Docket Item # 8
DEVELOPMENT SPECIAL USE PERMIT #2002-0005
RAMSAY SCHOOL & FORD NATURE CENTER

Planning Commission Meeting
February 4, 2003

ISSUE: Consideration of a request for a development special use permit, with site plan, for renovations to the existing school and construction of a nature center addition.

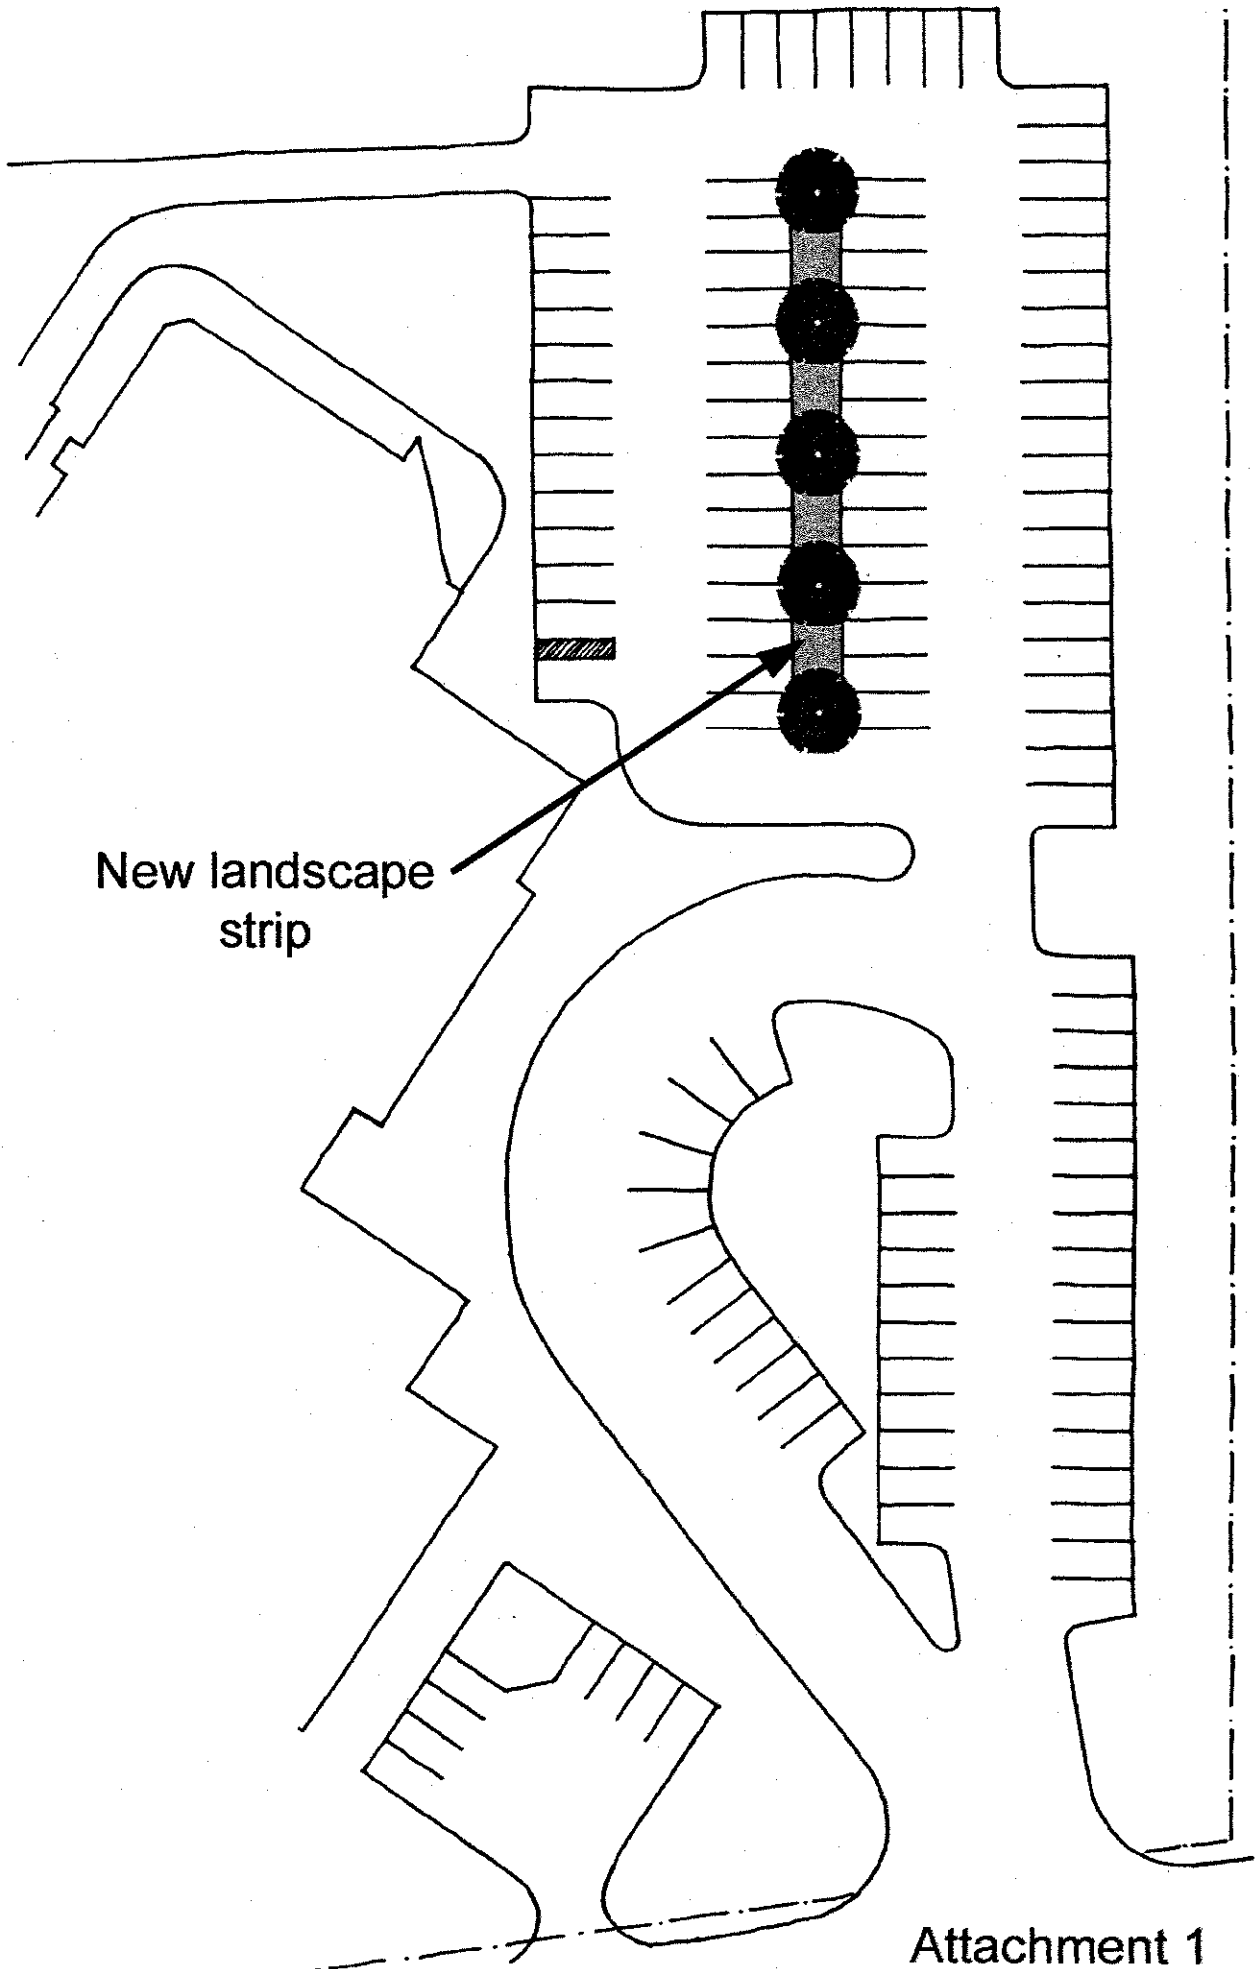
- R-1 The tree preservation for the Beech Tree (large tree in the back of the site) needs to run along the existing pavement, not at the drip line, as previously recommended. This will allow for an additional few feet of breathing space for the tree.

- R-2 The tree preservation fence for the Beech needs to be Board on Board Batten fencing and extend along three sides of the tree, outside of the drip line, leaving the south side open.

- R-3 The six foot high construction fence needs to be located on the north side of the tree preservation fencing, inside the limits of construction.
- R-4 The limits of construction line needs to be revised to graphically represent the Beech tree correctly. The line should not follow the drip line around the outside of the tree. The *tree* needs to remain outside of the limits of construction; the line should go along the pavement edge, adjacent to the tree preservation symbol and the construction fence symbol.

- c. Revise the tree preservation for the large Beech Tree on the south side of the proposed addition to incorporate the following:
 - i. Relocate the tree preservation to run along the existing pavement, not at the drip line, to provide an additional few feet of undisturbed setback from the

- tree;
 - ii. Construct the tree preservation fence in Board on Board Batten and extend the fence along three sides of the tree, outside of the drip line, leaving the south side open;

- iii. Relocate the six foot high construction fence needs to the north side of the tree preservation fencing and inside the limits of construction;
 - iv. Revise the limits of construction line to graphically represent the Beech tree correctly. The line should not follow the drip line around the outside of the tree. The *tree* needs to remain outside of the limits of construction; the line should go along the pavement edge, adjacent to the tree preservation symbol and the construction fence symbol;

NORTH ELEVATION

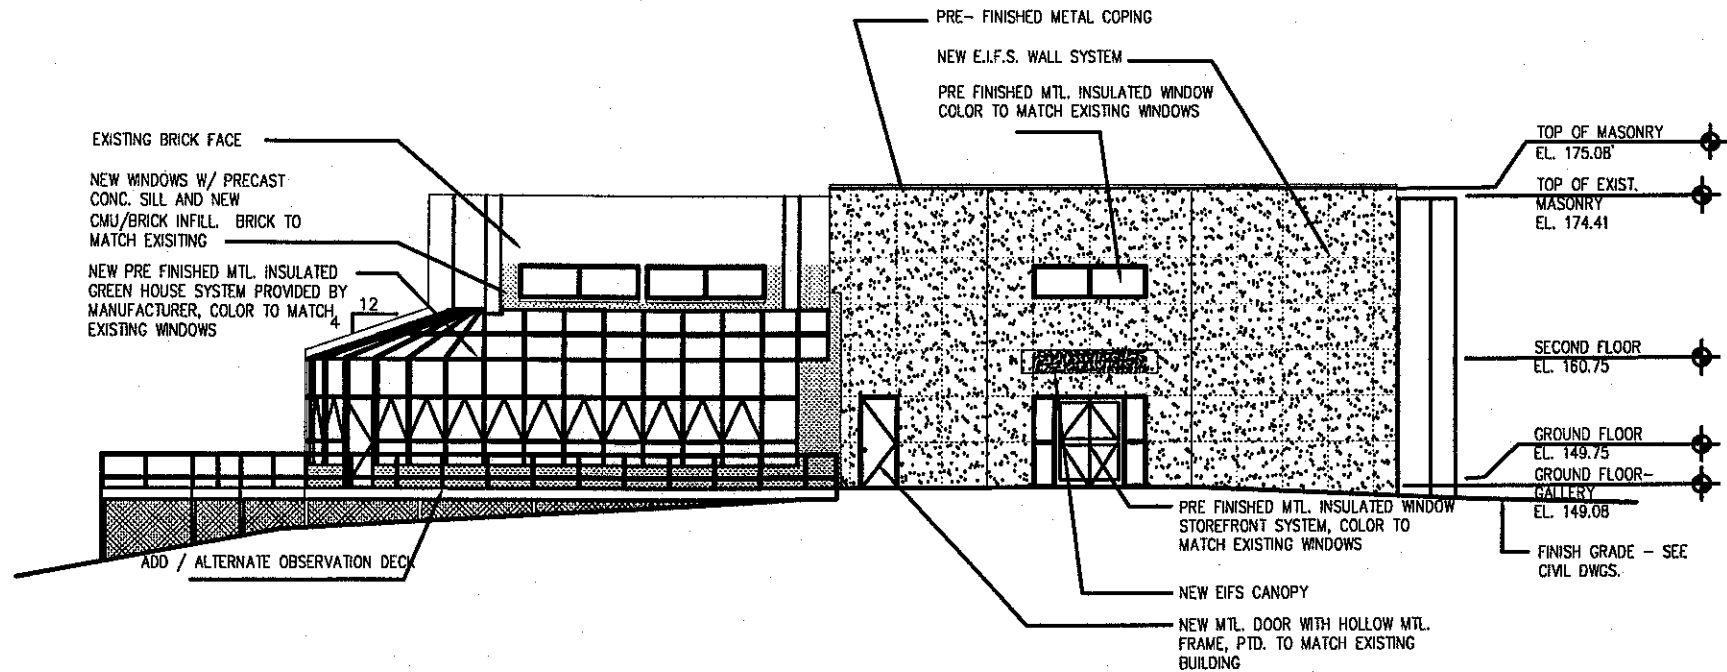
26. The final design for the building addition shall be consistent in architectural style, character and material quality such as masonry and the standing seam metal roof as depicted on the preliminary architectural elevations and also provide additional refinements to the satisfaction of the Director of Planning & Zoning that shall include:

- a. The window fenestration of the proposed addition shall be refined to be more consistent with the existing school.
 - b. Reducing the use of the EIFS surface treatment and replacing with higher quality materials such as masonry where possible.

- c. The brick for the proposed addition shall match the existing facility. (P&Z)
27. The width of the drive aisle at the west end of the rear parking lot shall be increased from 18 ft. to 22 ft. to provide adequate vehicle circulation and access to the fire lane. The nature center addition and school classrooms shall provide the number of parking spaces required by the Zoning Ordinance. (P&Z)
